UNITED STATES PATENT AND TRADEMARK OFFICE

| APPLICATION NO. | FILING DATE | FIRST NAMED INVENTOR | ATTORNEY DOCKET NO. | CONFIRMATION NO. |
|----------------------------------|-------------|----------------------|-----------------------|------------------|
| 10/698,961 | 10/31/2003 | Sivakumar Ramasamy | 0275M-000666/COB | 8815 |

| Office Action Summary | Application No. 10/698,961 | Applicant(s) RAMASAMY ET AL. | |

DETAILED ACTION

Bregenzer et al. GB 2,065,011 A1.

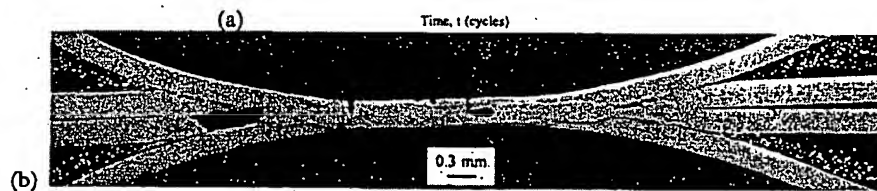
Applicant has amended claim 42 in an attempt to define over the Bregenzer et al. reference. The claim now calls for "wherein the first and second metallic layers are welded together". This is already an inherent property of the composite panel taught in the Bregenzer et al. reference, as evidenced by NPL T.W. Clyne et al., "Development of a New Ultra-Light Metallic Sheet Material", January 2002, Research Proposal for Cambridge-MIT Institute. Although the Bregenzer et al. reference appears to be silent as to what happens to the laminated sheets during welding, the Clyne et al. reference expressly fills in the gaps of inherency where the Bregenzer et al. reference is silent.

EP 1 060 826 A1

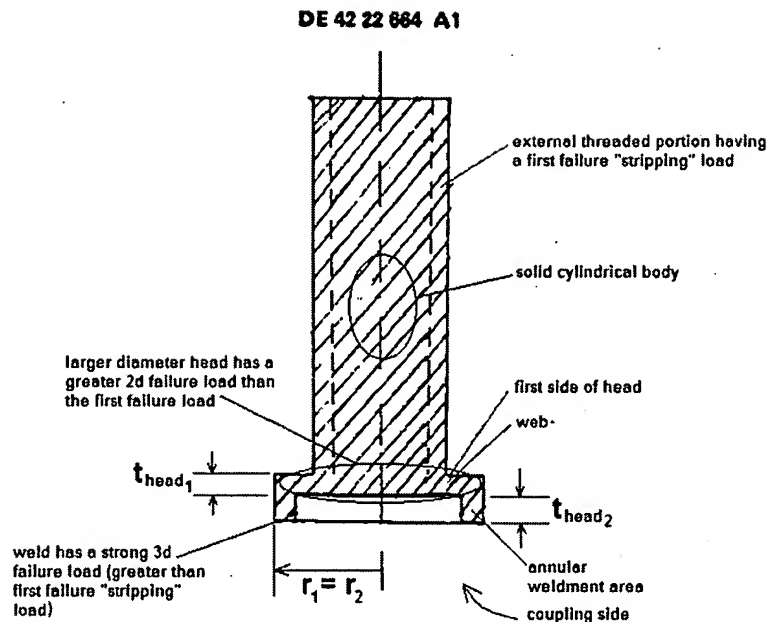
[7] Claims 1-3, 5, and 8-10 are rejected under 35 U.S.C. 102(b) as being anticipated by EP 1060826 A1. See annotated figure below.

In short, the EP 1060826 A1 reference teaches a weldable ring stud fastener having a solid cylindrical body having an exterior threaded portion, and a web having a first head thickness that is greater than a second annular weldment area head thickness; wherein the outer radius of the web and annular weldment area is the same. Note that Applicant does not significantly limit "annular weldment area" and/or how "thickness" is measured, and therefore the EP 1060826 A1 reference broadly reads on the abovementioned claims.

U.S. Patent 4,689,958

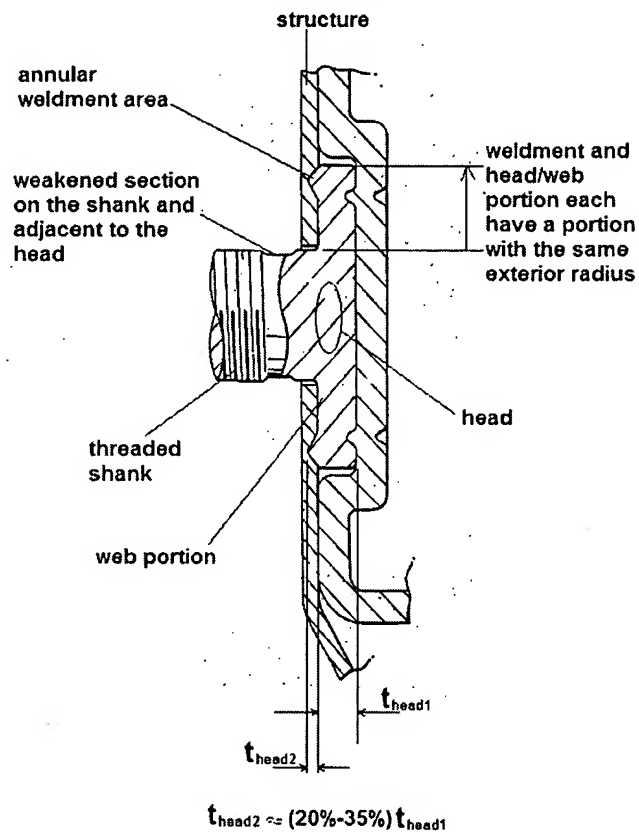
In short, Soyer teaches a weld stud having all of the claimed limitations disclosed, except for the **claimed thickness** of the annular weldment area and a **weakened portion** at the shank adjacent the head. It would be readily apparent that the external threads would fail (e.g., "strip") at a first failure load much less than the head/web portion would be sheared (at a second failure load). Further, the shank has a smaller cross-sectional area making it more prone to shearing than the larger head/web portion.

Arino et al. suggest a weld stud having many of the claimed limitations, but mainly suggests an annular weldment area having a thickness in the axial direction of approximately less than 50%, and even more specifically, about 20%-35% of the thickness of the head/web portion in the axial direction. See the annotated figure below. It is important that Arino et al. depict an annular weldment portion having such a thickness, because the weld stud is to be used with a structure (1) of decreased thickness (in order to reduce the weight of the part 3). In essence, Arino et al. make obvious, decreasing the thickness of an annular weldment area to the claimed relative size dimensions (e.g., 20%-35% of the head/web thickness), in order to perform successfully with thin sheet panel structures. The Arino et al. reference further suggests a weakened section on the shank positioned adjacent the head for a smooth thread clearance and transition.

At the time of invention, it would have been obvious to modify the thickness of the annular weldment taught by Soyer, as shown by Arino et al., so as to provide Soyer's device with the capability of being welded to thinner substrates without damage.

Bregenzer et al. GB 2,065,011 A1.

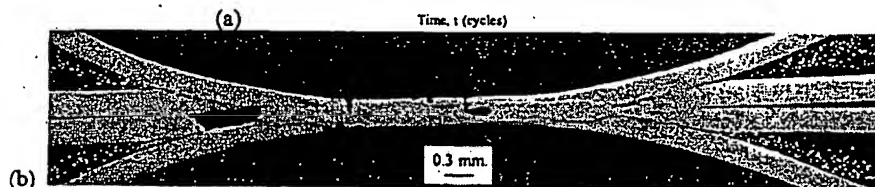
The Bregenzer et al. reference generally makes obvious using welding studs with laminate panels having first and second metallic layers "sandwiching" a polymer core. It is well-known to those of ordinary skill in the art that these metallic layers fuse together when welding takes place, and that at least a portion of the weldment area will be disposed within the panel after a welding process.

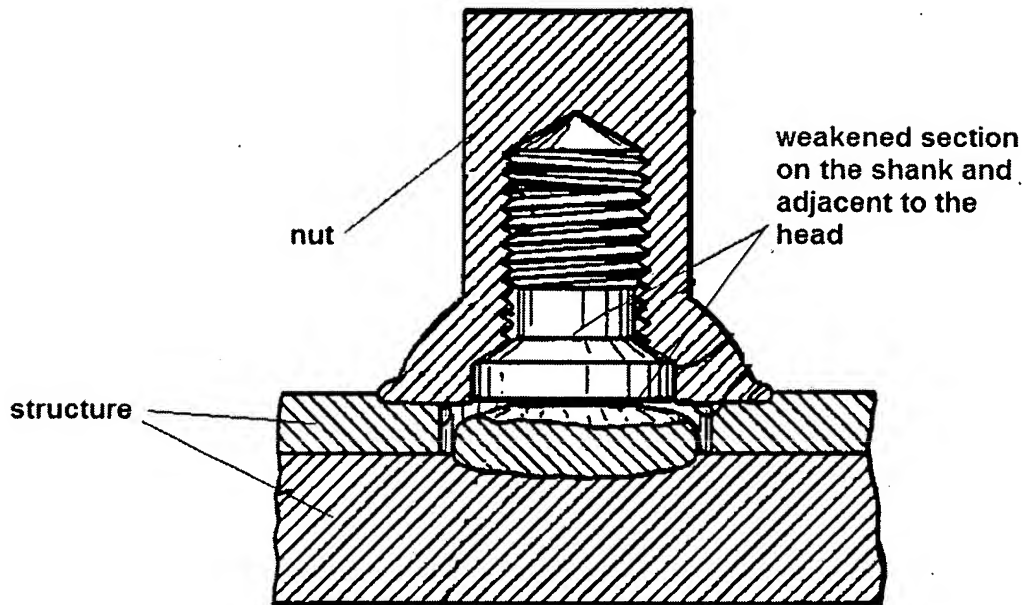
As for claims 6, and 7, merely changing the head thickness to be greater than 2.0 mm is not a patentable improvement over the prior art of record, as it has been held that a change in size is generally recognized as being within the level of ordinary skill in the art. *In re Rose*, 105 USPQ 237 (CCPA 1955). Furthermore, one of ordinary skill in the art would appreciate that

weld studs and other fasteners generally come in various sizes to suit different applications. In the instant case, Applicant's alleged improvement over the prior art is the relative thickness of an annular weldment area with respect to a web or head portion. EP 1060826 A1 clearly teaches this limitation (i.e., a second head thickness of the annular weldment area to be "less than 50% the first head thickness"). Stating a specific preferable dimension of a prior art device would be within the ordinary skill of a worker.

As discussed above, although the EP 1060826 A1 reference is silent as to the respective failure loads of claims 11 and 12, it would be readily apparent to those skilled in the art, that the external threads would fail (e.g., "strip") at a first failure load much less than the head/web portion would be sheared (at a second failure load). Further, the shank has a smaller cross-sectional area making it more prone to shearing and failure than the larger and wider head/web portion. Similarly, those of ordinary skill in the art would recognize that the weld portion would stay intact under much higher loads (third failure load) than the torque required for stripping the threads of the shank (first failure load).

U.S. Patent 5,054,980

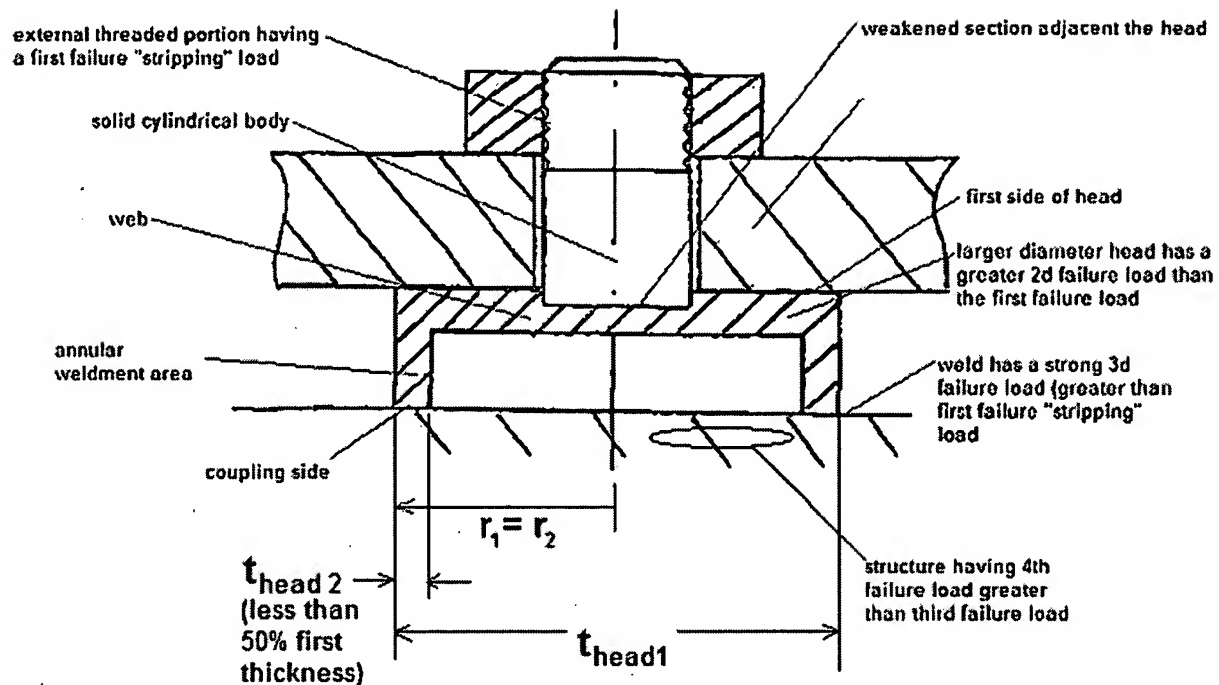
Bidefeld suggests using a nut with a weld stud in order to secure a structure to the structure the weld stud is attached to. It would be apparent to those of ordinary skill in the art, that the shank and nut have a mating threaded portion that would strip at a lower first/fourth failure load, before the weld portion's third failure load. Note that Bidefeld further teaches a weakened portion on the shank adjacent to the head that could be used as a thread clearance, to prevent weld splash to the threads, or to lighten the weight of the fastener as an intended use.

At the time of invention, it would have been obvious to one having an ordinary skill in the art to employ a nut having a fourth failure load less than the third failure load of the weldment, so as to aid in securing a structure to the structure to which the weld stud is permanently attached. It would have further been obvious to employ a weakened section adjacent the head, so as to provide a clearance for the threads, make the fastener lighter by removing unnecessary material, or in order to serve as a thread safeguard from weld splash.
